Technical Service Bulletin

MODEL(S) AFFECTED: T16 (Only machines where customer has noted CAN bus failures/error messages)

SUBJECT: Incorrect CAN bus termination resistance possibly causing CAN bus failures/error messages.

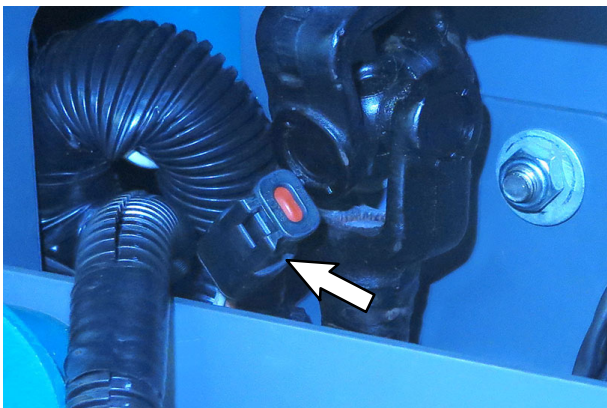
3. Remove electrical panel from machine to access portion of main wire harness/terminal resistor located inside steering support channel.

4. Disconnect resistor from main wire harness.

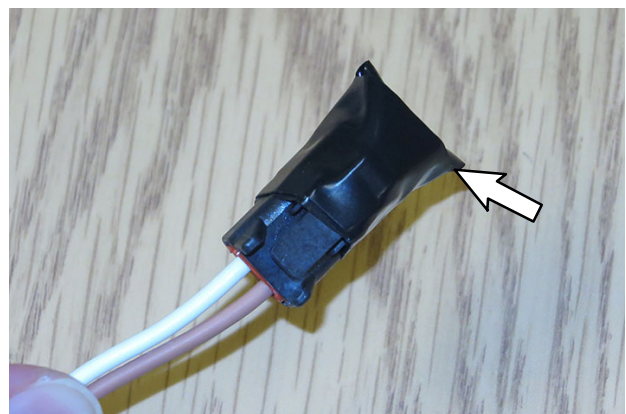
5. Use ohmmeter to test resistance at main wire harness connection where removed resistor was previously located. Should be nominal value of 60Ω.

If less than 60Ω, do not reinstall resistor, tape connector end with electrical tape so connection is completely covered. Discard removed resistor.
